SUBJECT: ISSUANCE OF AMENDMENT (TAC NO. 76934) (TS 285)

The Commission has issued the enclosed Amendment No. 181, to Facility Operating License No. DPR-52 for the Browns Ferry Nuclear Plant, Unit 2. This amendment is in response to your application dated June 8, 1990.

The amendment revises the Technical Specifications (TS) to allow for expanded reactor operation in a region of higher core power versus core flow.

Amendment No. 181  
License No. DPR-52

**APRM Flow Reference Scram and APRM Rod Block Settings**  
**Fig. 2.1-1**

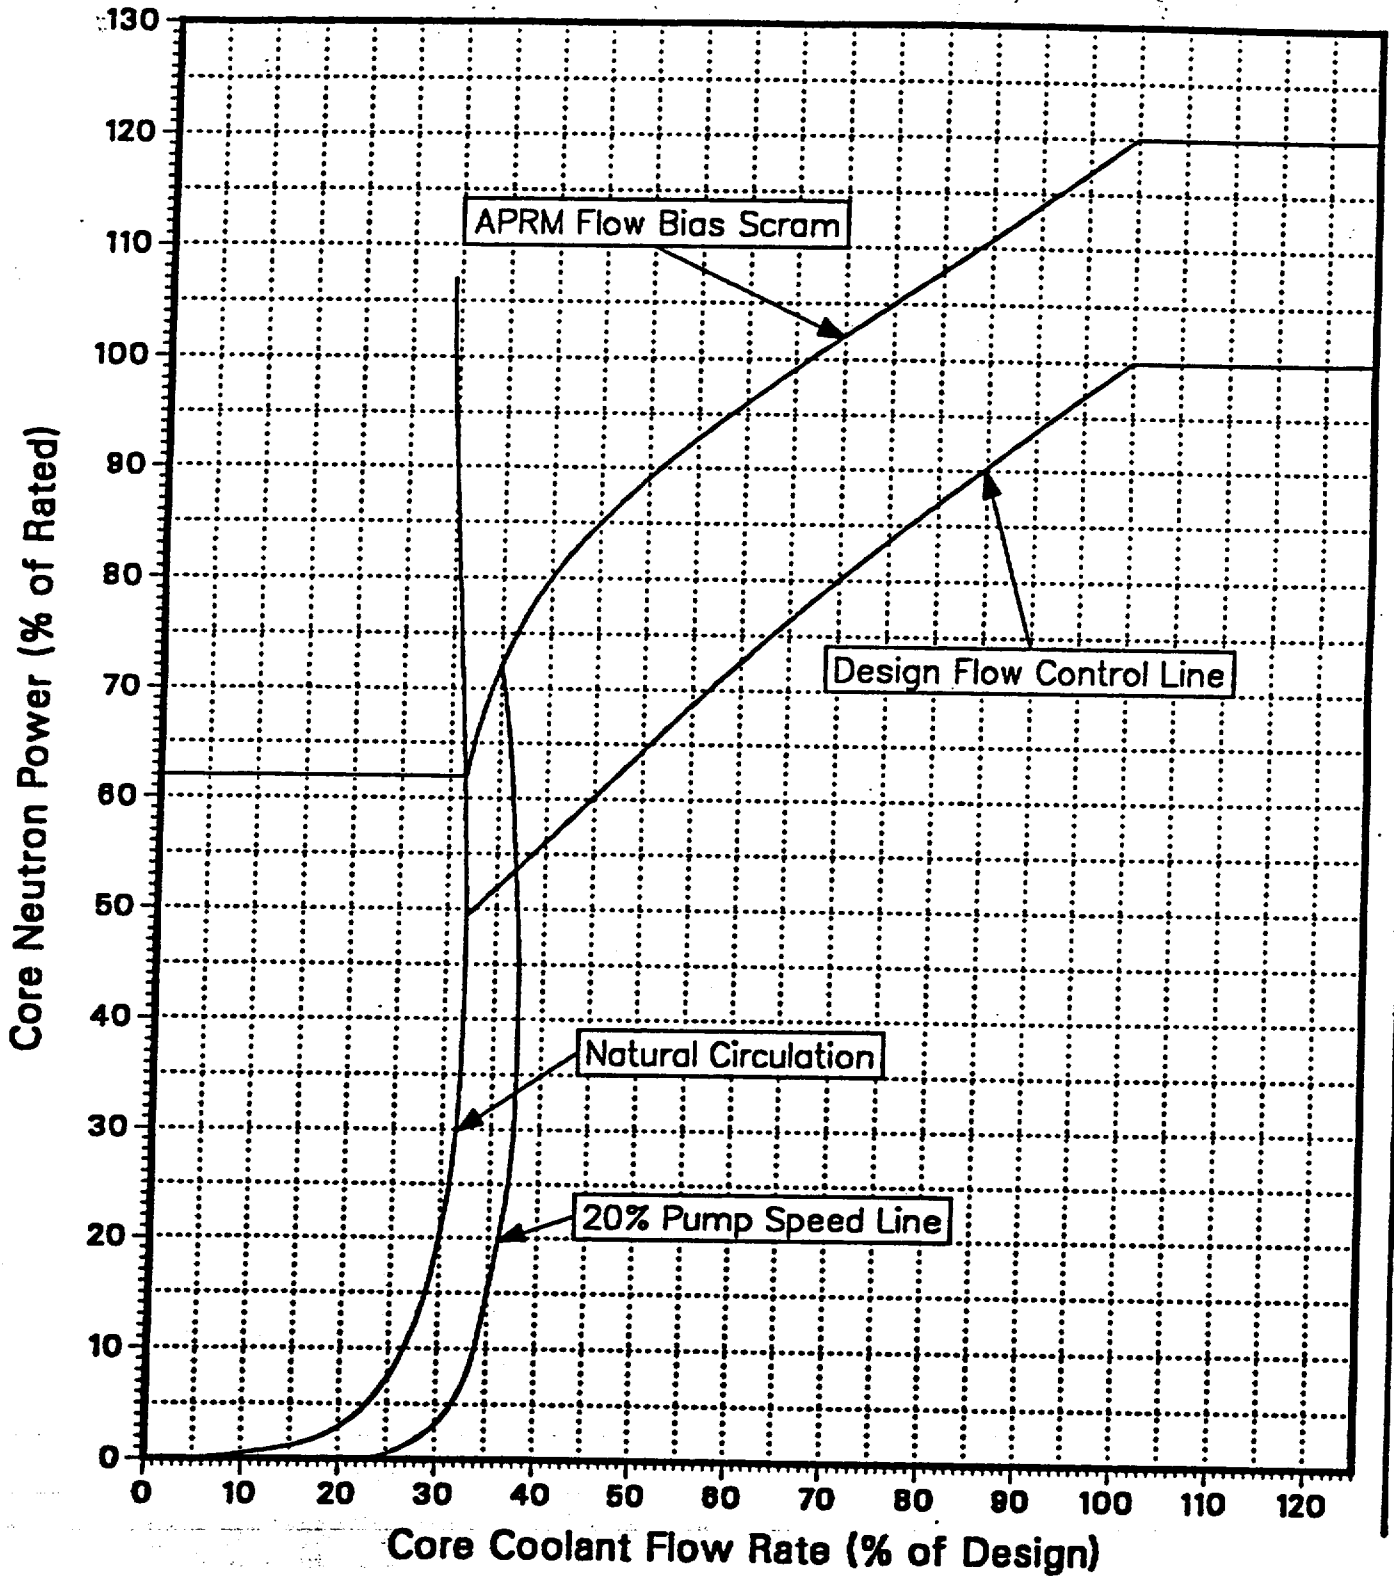
(3) TS Figures 2.1-1 and 2.1-2

Figures are replaced with revised Figures to show the revised flow-biased scram and rod block lines based on equations developed from the trip settings in items (1) and (2) above.

The ELLL proposal changes the APRM flux scram lines on the power/flow map and permits operation up to the new APRM flux scram line ( $0.58W + 62\%$ ) and up to the intersection with the 100 percent power line occurring at a flow of 87 percent. This is a standard change for ELLL. The flow-biased rod block trip equation is changed to  $0.58W + 50\%$  with a maximum value of 108%. These changes are acceptable since they are consistent with the applicable design safety limits.
